Addendum #1
Solicitation #25-99213
2025 Citywide Patch and Sidewalk

APPENDIX C
RAIL CROSSING RESTORATION

Location Fremont St RR Crossing

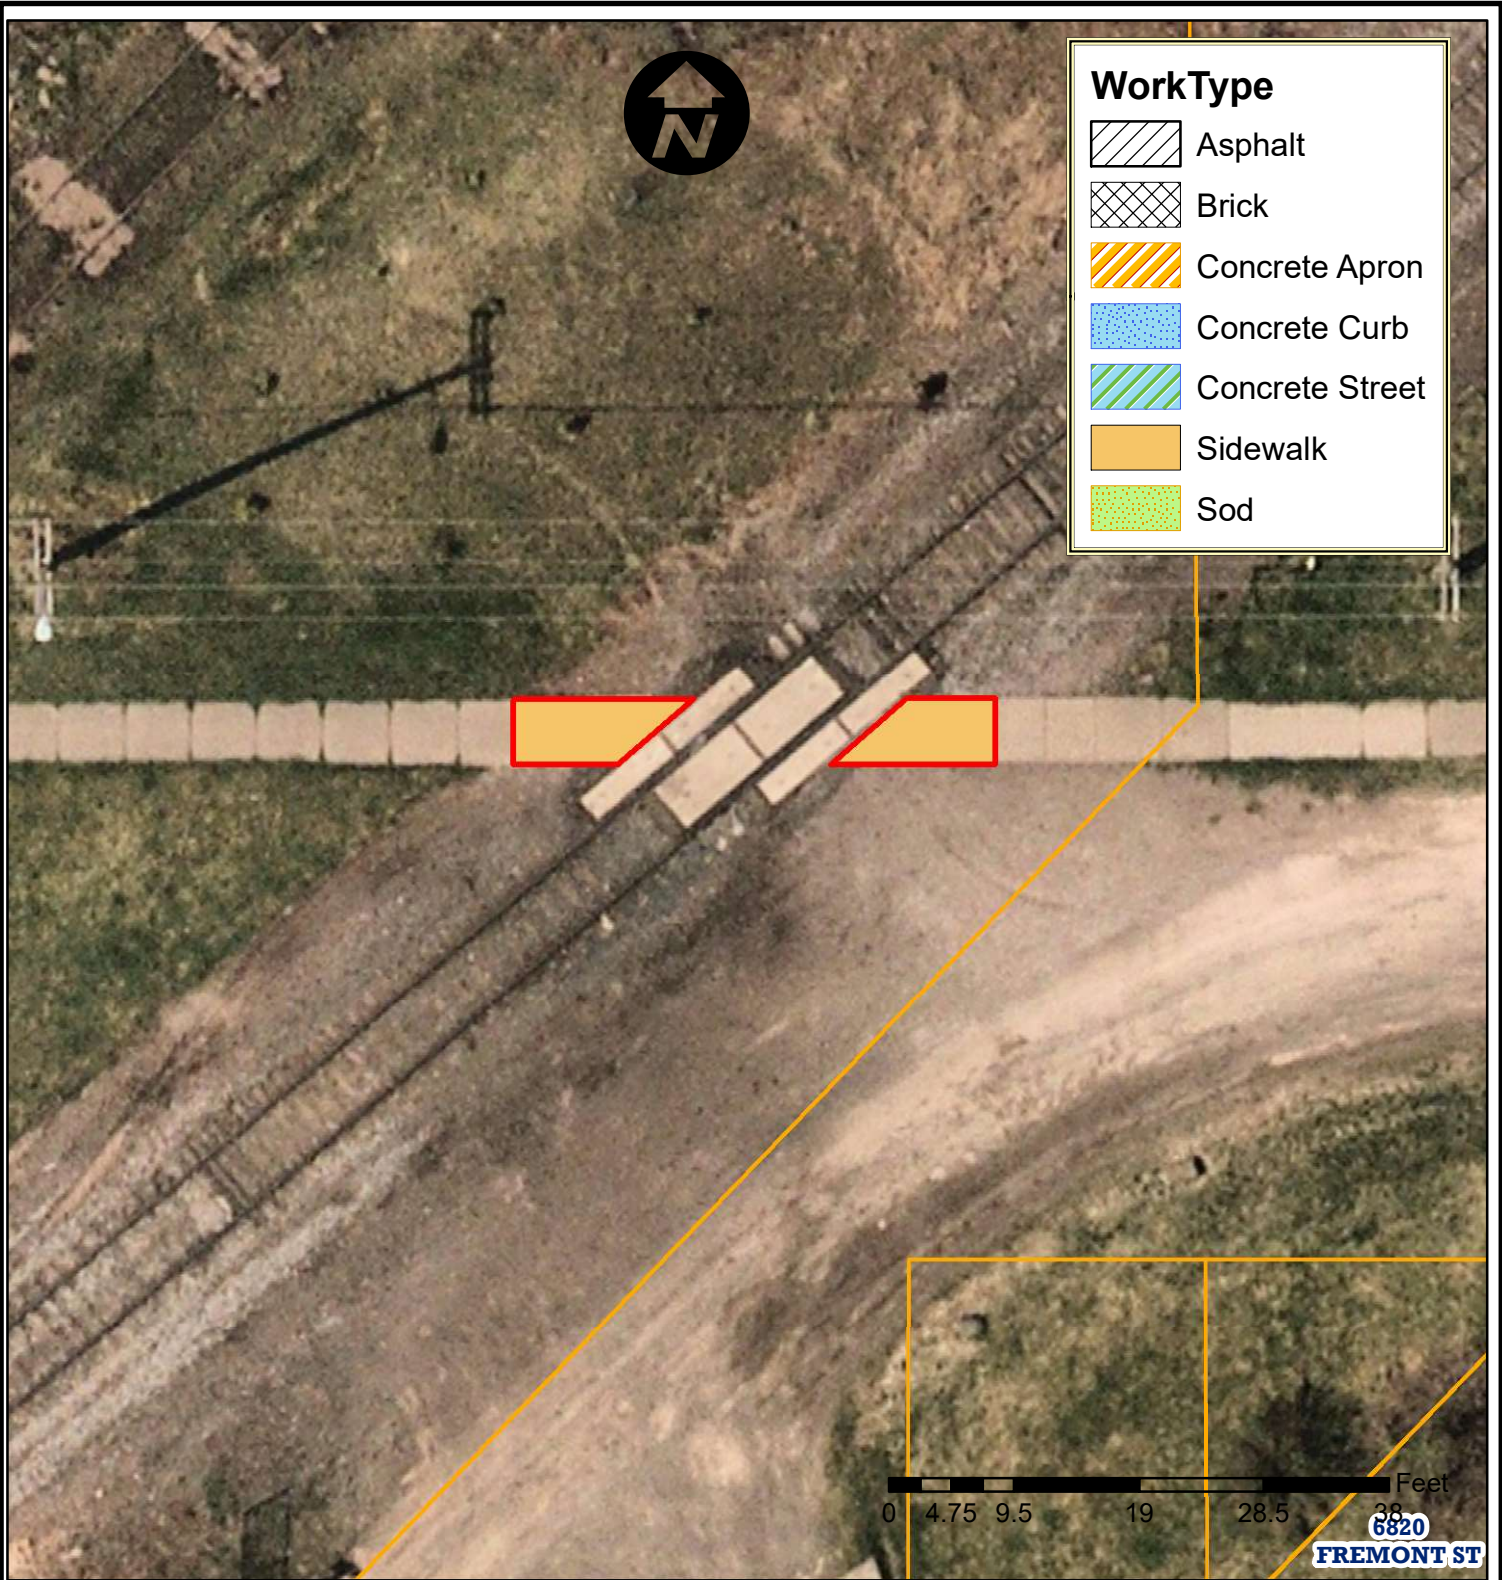
3. Please add the following to SP-18 (2211) Aggregate Base-Quality Compaction:
“BNSF has already completed their work at the Fremont Street sidewalk crossing and restored the removed pavement with aggregate base. Both crossing restorations shall be compacted in accordance with MnDOT 2106.3G2, Quality Compaction.”

4. Please add the following to SP-21 (2360) Plant Mixed Asphalt Pavement-Street Restoration patching: “This work also includes the placement of bituminous along each side of each of the concrete pads for the railroad crossings. Minimum width of the patch area is 5 feet, but will depend on the disturbance done by BNSF. Contractor shall coordinate the work with Duncan Schwensohn, city of Duluth Senior Project Engineer to coordinate work schedules with BNSF. At least 7 working days notice is required prior to construction in order to provide road closure notifications.”
